ORDINANCE 94-18

TO AMEND THE BLOOMINGTON ZONING MAPS FROM SI to RL,
GRANT PUD DESIGNATION, AND APPROVE OUTLINE PLAN
Re: 1730 N. Range Road
(Regency Associates, Petitioner)

PRELIMINARY STAFF REPORT

Subj: RL/PUD-15-94 Regency Assocs. 1730 N. Range Rd.

ROAD IMPROVEMENT
RL/PUD-15-94 37

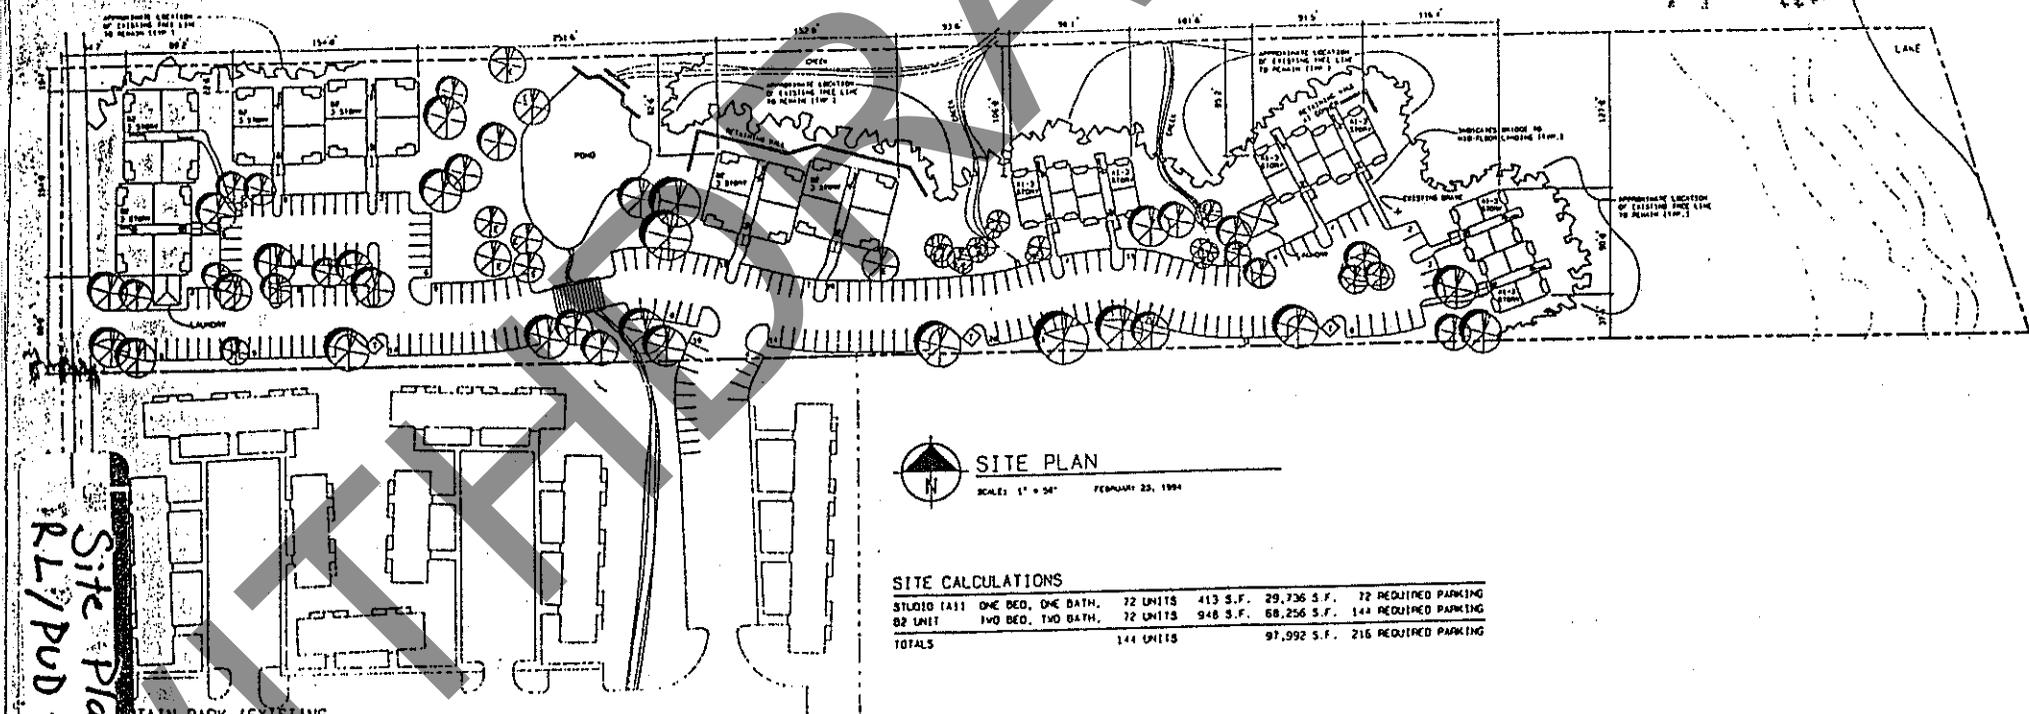
petitioner plans to widen and improve Range north of the access to Indiana University's construction site. Currently the petitioner is proposing a 28' standard as compared with IU's 31' width. Since there will necessarily be tree removal involved, staff will review exact placement of the improvements.

Site Plan
 RL/PUD - 15-94

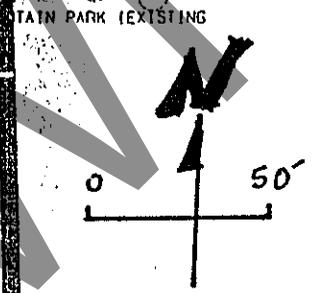
5. The density issue is a difficult one because the high density use to the south conflicts with this property's location in a heavily vegetated site in the Lake Griffy Watershed. The Environmental Commission, however, is advocating the deletion of structure number 3 from the proposed site plan. This would reduce the development's density to 12 units/acre rather than 14.4 but still put it within the Master Plan's range of 12-15 units/acre for high density residential housing. The location of structure number 3 is entirely vegetated and framed by two ravines. The underlying slope is steepest of any of the structures (approximately 15-16 percent). It requires more parking than the structures located further to the east (48 spaces as opposed to 24). We urge that the Plan Commission consider the positive environmental impacts of reduced impervious area and the maintenance of existing terrain in evaluating the density issue.

4. Density of development is always an issue for properties in lake watershed areas. The existing topography and forest cover dictate a lower density of land use. Contiguous development to the south would support more intense land usage. In order to better protect natural features and insure the long-term quality of the watershed, the Environmental Commission would support a loss of one structure on the site. This would reduce the structures to 5 and the number of total units to 120 (12 units per acre).

Sediment Control Pond
 RL/PUD-15-94 38

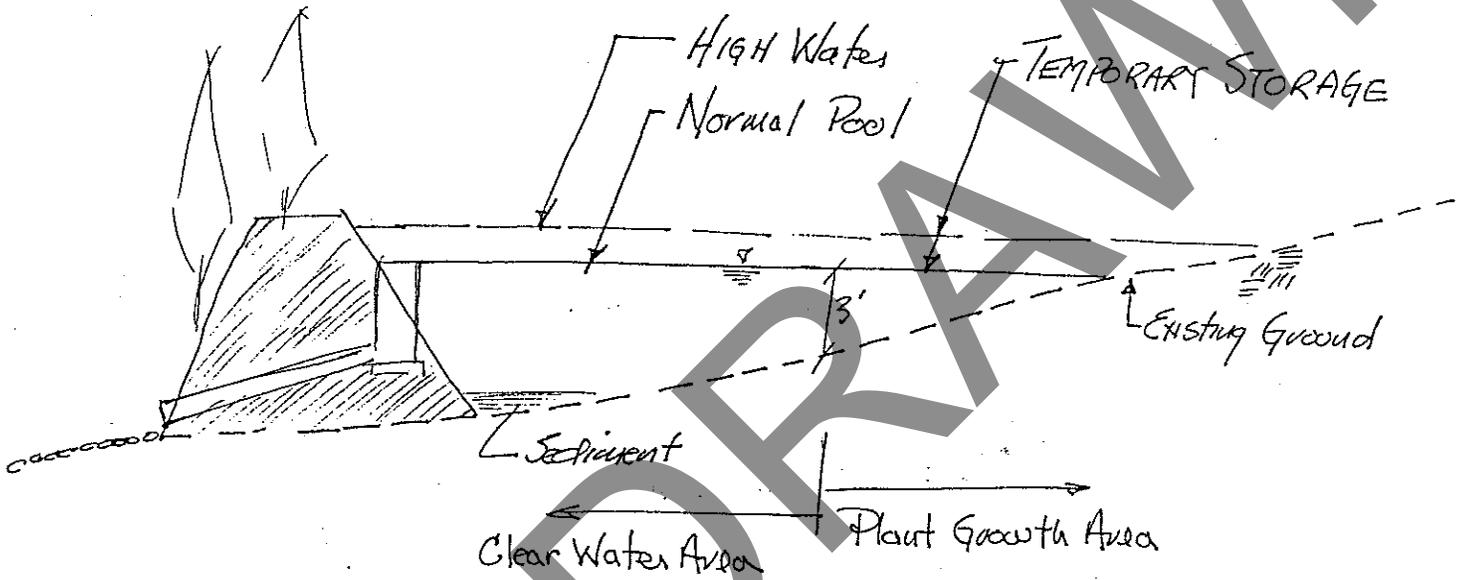
The petitioner has included a cross section of the sediment control pond which would be vegetated from a depth of 3' to the perimeter of the pond. This pond would retain sediment from both the parking areas in the existing Fountain Park site and the new ten acre development. The design would channel run-off via a storm sewer system to a single detention area. The detention area will feature vegetative filters.

2. We are pleased at the petitioner's proposal that the detention pond be partially vegetated to provide greater filtration of stormwater pollutants. The petitioner has indicated a willingness to establish approximately 50 percent vegetation cover in the pond and work with wetlands vegetation specialists to select appropriate pond vegetation. The Environmental Commission expects to see these pond design issues resolved by development plan stage. We also recommend that a pond maintenance program be worked out at this stage. Included in this maintenance program should be specific information about inspections and financial responsibility for pond upkeep.
